**Randwick City  
Council**  
a sense of community

**DA COMPLIANCE REPORTS**

**PLANNING COMMITTEE MEETING  
TUESDAY, 11 APRIL, 2017**

<b>Folder /DA No:</b>	DA/595/2016
<b>PROPERTY:</b>	773-775 Anzac Parade, MAROUBRA NSW 2035
<b>Proposal:</b>	Demolition of all structures on site and construction of a new part 6 and part 7 storey mixed use development into two building forms comprising of two commercial tenancies at ground floor level, 24 residential dwellings above, basement parking for 31 vehicles, associated site and landscape works and strata subdivision.
<b>Recommendation:</b>	Refusal

**Anticipated Building Envelopes for Block 10**

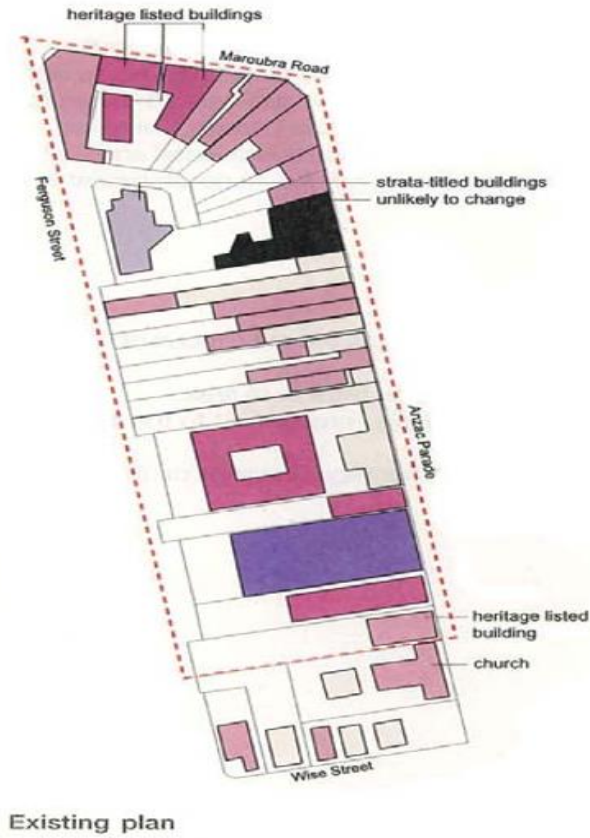
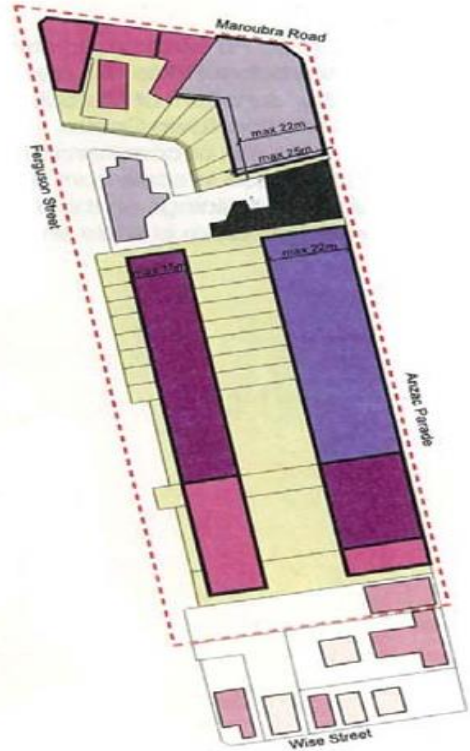
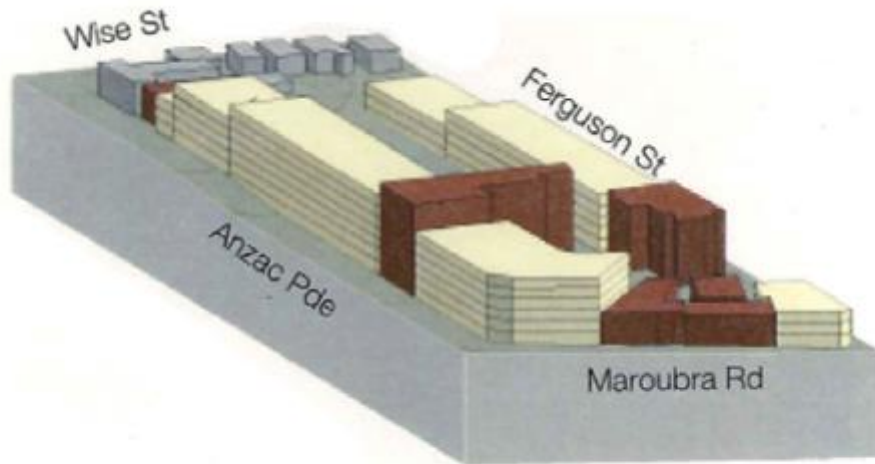
DCP Clause	Controls	Proposal	Compliance
		<p>The front building facing Anzac parade can have a nil setback at the front but should be setback from the boundary towards the centre to reduce its bulk and visual dominance and provide some space and separation from the existing windows along the southern elevation of No.767 Anzac Parade.</p> <p>The upper residential levels of the rear building have the balconies located on the rear boundary which is inconsistent with the established rear setback of balconies at No.767 Anzac Parade.</p>	
<b>4.2</b>	<b>Block 10 Controls</b>		
	<p><i>i) Building Envelope Plan</i> Anzac Parade – 5-7 Storey’s Ferguson Street – 3-5 Storey’s</p> <p><i>ii) Building Use</i> Anzac parade – 2 levels commercial, residential above Ferguson Street – 1 level commercial residential above</p>	<p>The proposed development exceeds the number of storeys along the front and rear of the site.</p> <p>Only the ground floor level is designed as commercial/retail off Anzac Parade. No justification is provided to explain why a first floor commercial component is not included within the scheme along the Anzac Parade road frontage. Council has approved first floor residential uses in similar developments however has requested that the floor to ceiling heights be increased to 3.3m at this level which provides flexibility for</p>	<p><b>No</b></p> <p><b>No</b></p> <p><b>No</b></p> <p><b>No</b></p>

6. The bulk and scale of the proposal is considered to be inappropriate especially in relation to the height and siting of the rear building and the proposal fails to comply with the Building Envelope (Section 3.1.3) and Height controls (Block 10 Section 4.2) as outlined in the Randwick Development Control Plan 2013. The siting of the proposal will adversely affect the outlook and amenity of the kitchen and balcony areas of No.767 Anzac Parade.
